**ADDENDUM No. 1**

**TO THE RFP DOCUMENTS – RFP PR-23-04**

**Bob Korn Memorial Swimming Pool Liner Replacement**

**CITY OF CORDOVA, AK**

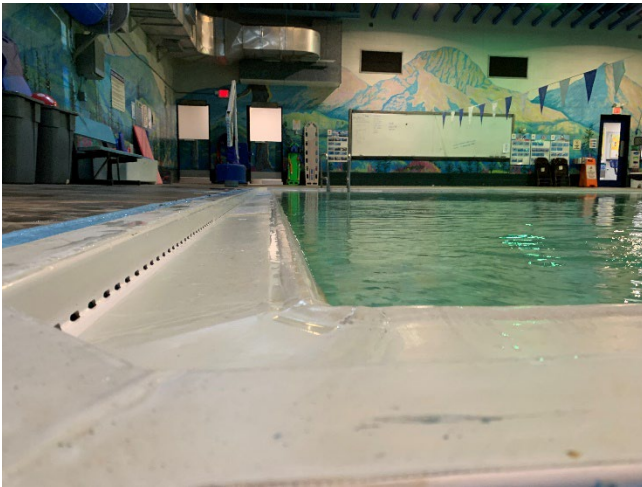
Q1. Per the item 101 Intent of the City, re-leveling of the Pool Rim. Is there any structural information on the releveling?

A1. No. The extent of the leveling needed is very minor, it is on the order of ¼" to ½" and the intent of the re-leveling is to use shim stock prior to applying the liner. Below are images of the pools condition.
